Re: Docket No. 461A - CSC 461A Greenwich Substation and Line Project - Petition for Reconsideration

This letter provides the response to requests for the information listed below.

CL&P dba Eversource Energy
Docket No. 461A

|| Q-TOWN-005, Page 1 of 1

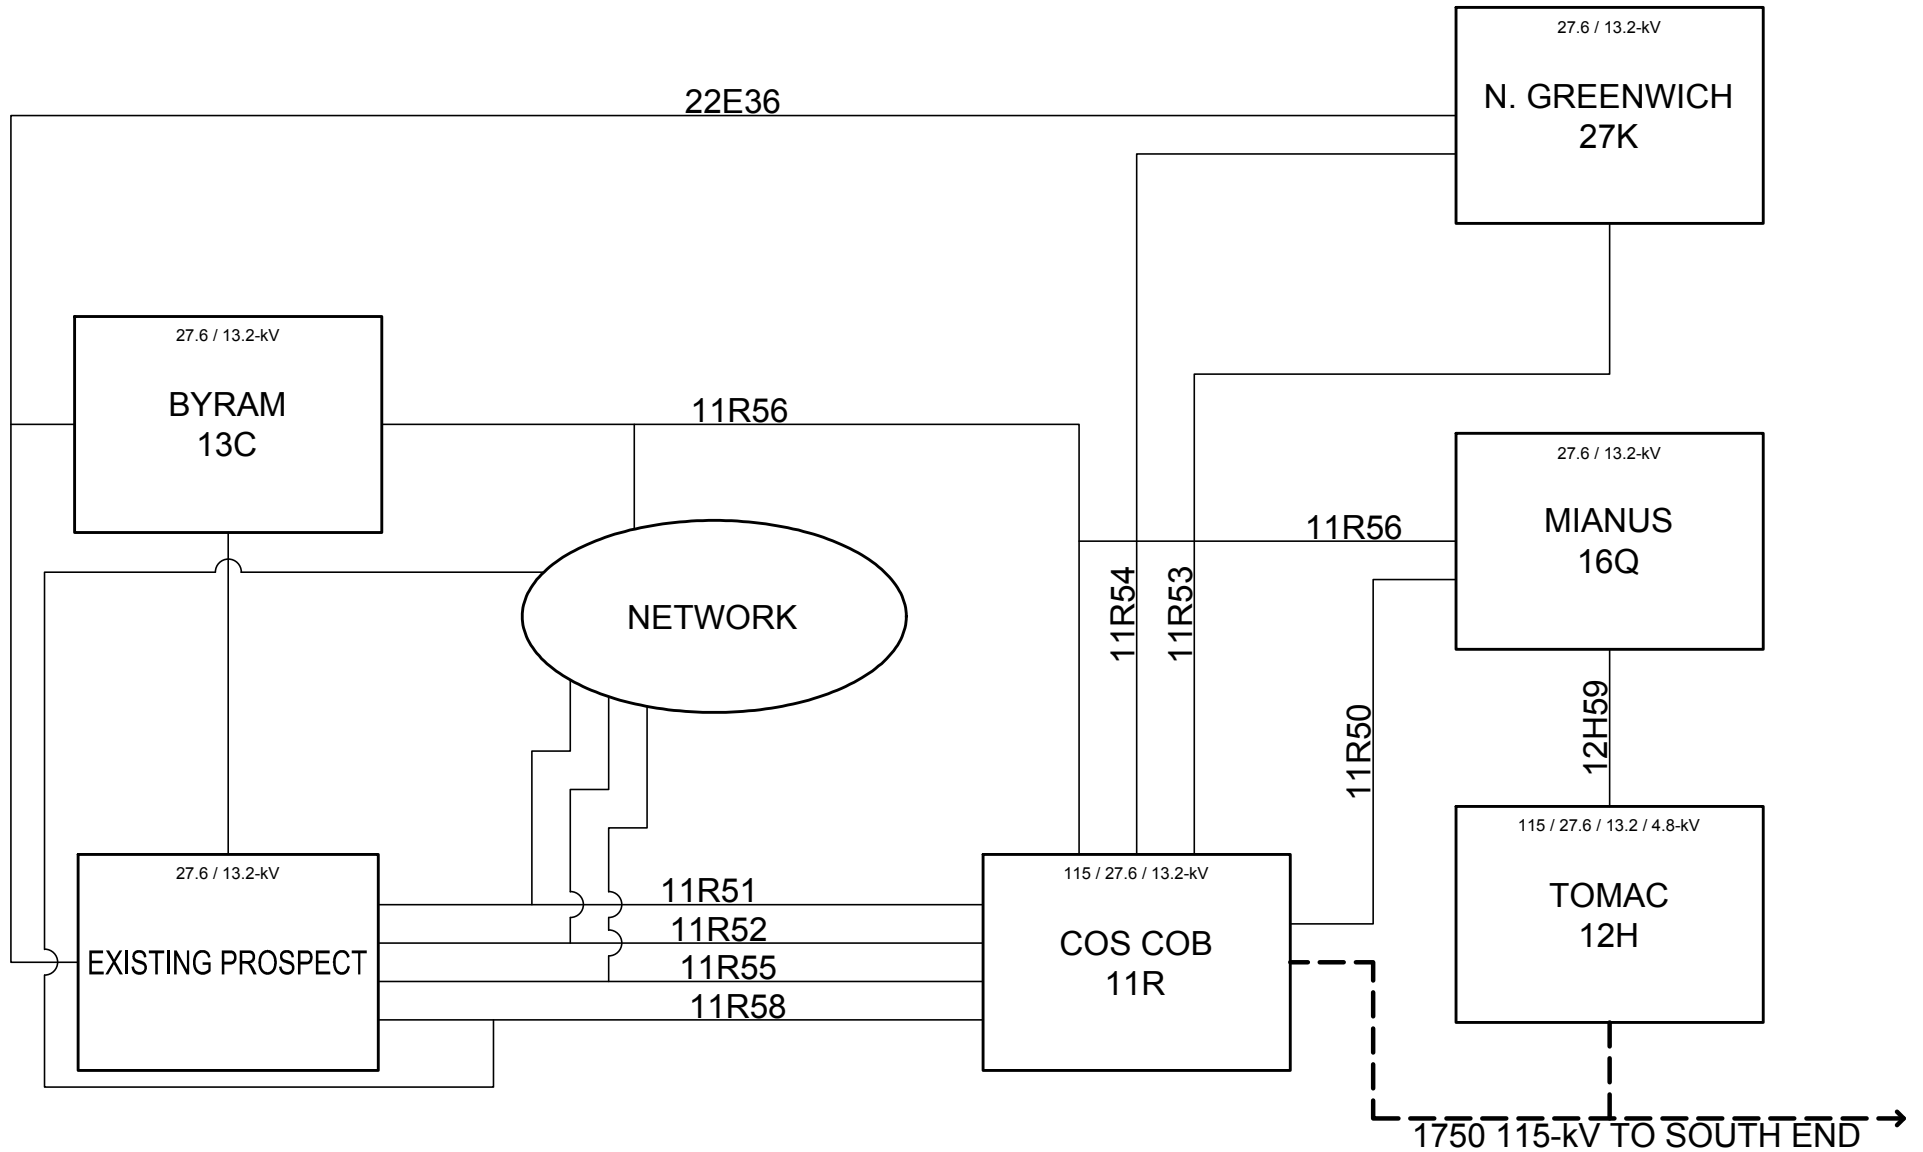
Reference Figure 5 of Pre-Filed Testimony at p. 10. Figure 5 depicts a 115-kV transmission line identified as "1750" supplying electricity to the Tomac Substation. However, this tap to the 115-kV transmission line is not shown on Figure 1 on page E-4 of the original Application dated June 2015 in Docket 461 ("2015 Application"), or on Figure 1 on page 4 of the Pre-Filed Testimony. Explain whether this transmission tie to the Tomac Substation currently exists or whether Eversource intends to build that transmission tie in conjunction with either the Proposed Modified Project or the Alternate Modified Project.

If the response to the preceding interrogatory is that the 115-kV 1750 transmission line's connection to the Tomac Substation currently exists, please provide an accurate Figure 1 on page 4 of the Pre-Filed Testimony reflecting this tap. Please furnish a one line drawing to show how the Tomac Substation has the capability of being supplied either by the 115-kV 1750 transmission line or by the 27.6-kV feeders originating from the Cos Cob Substation. Please include feeder 12H59 in that one line drawing.

The 1750 line tap currently exists and is shown in the attached figure.

Please reference the diagram which has been included in Q-TOWN-005. The Figure included in Q-TOWN-005 includes the existing 115-kV 1750 Line as a dashed, black line. The diagram also includes the 115-kV transmission tap from the 1750 Line to Tomac Substation. In addition to the 115-kV transmission line, the diagram also identifies the 27.6-kV path that originates at Cos Cob Substation, passes through Mianus Substation, and ends at Tomac Substation. The 27.6-kV 11R50 and 11R56 feeders connect Cos Cob and Mianus Substations while the 27.6-kV 12H59 feeder connects Mianus and Tomac Substations.

||Q-TOWN-070, Page 1 of 1

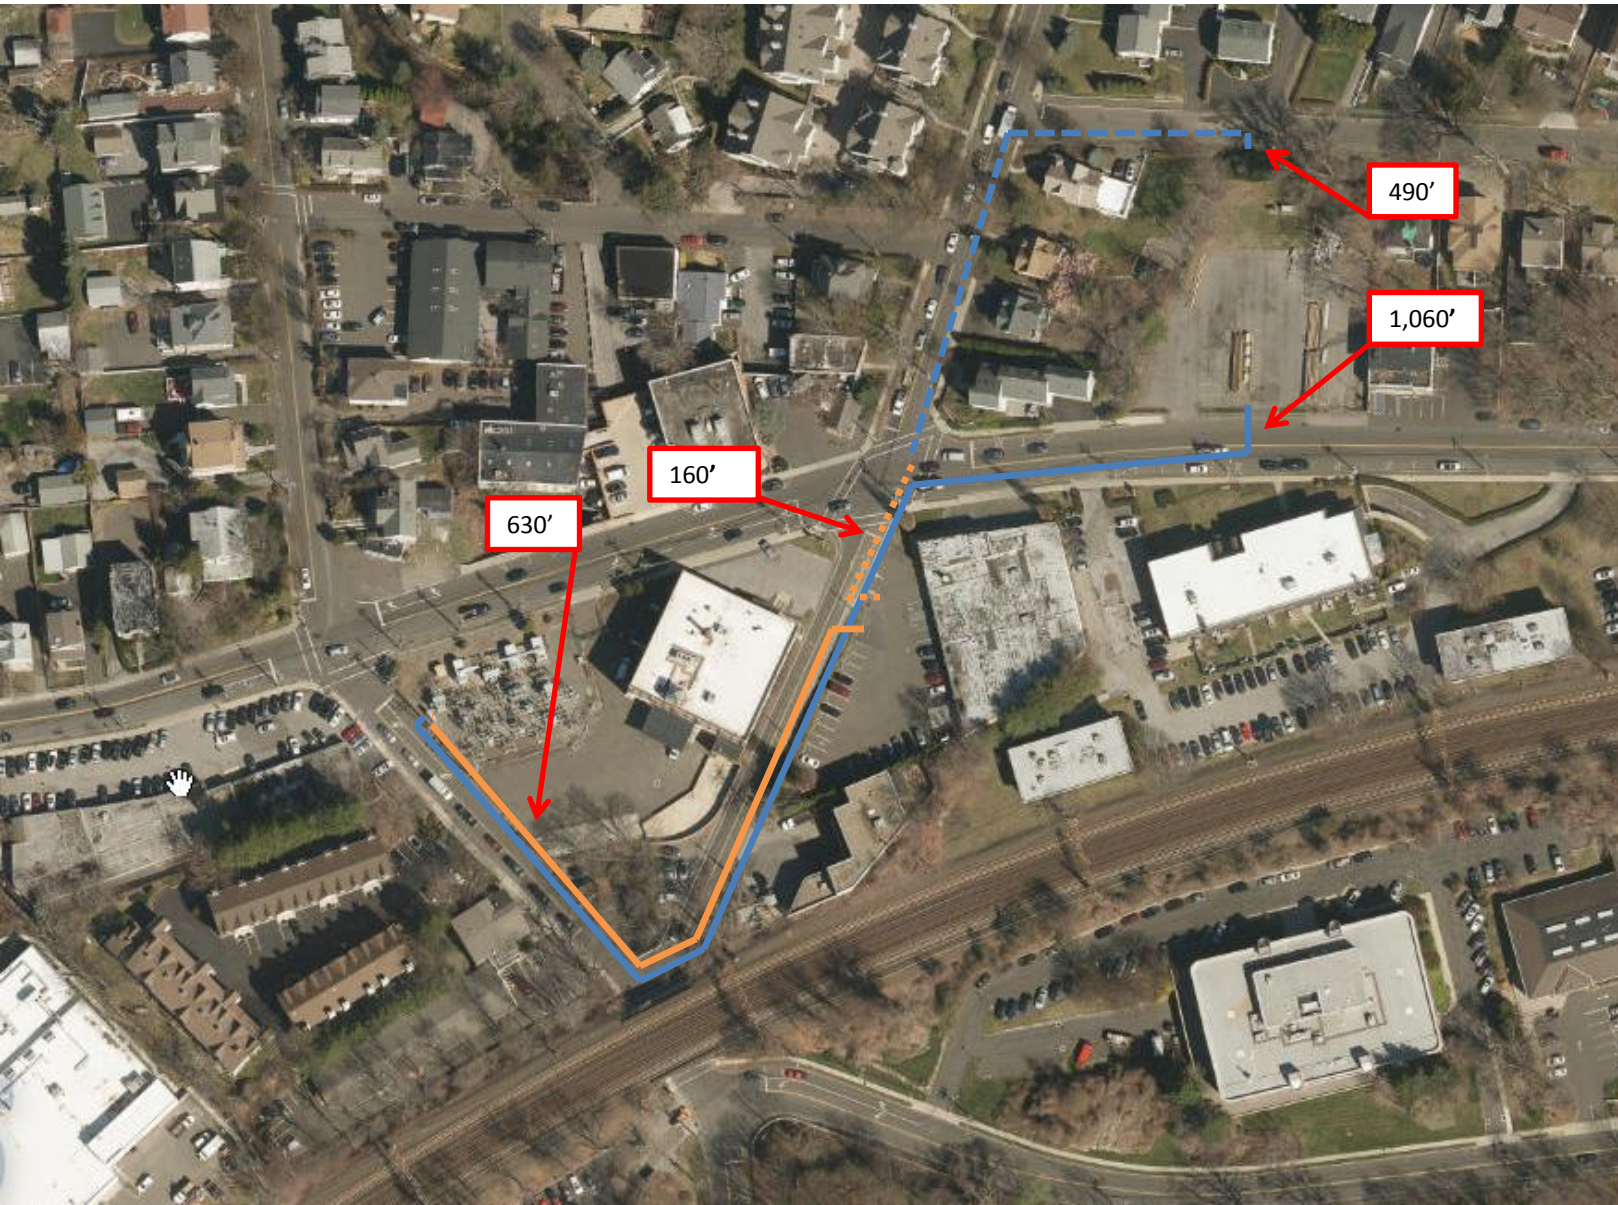
Reference the diagram entitled "Simplified 13.2kV Proposal" attached to Eversource's Response to Q-CSC-024 dated June 12, 2017. Please provide a revised diagram indicating the circuit identifying numbers (e.g., "11R3") for each circuit identified on the diagram.
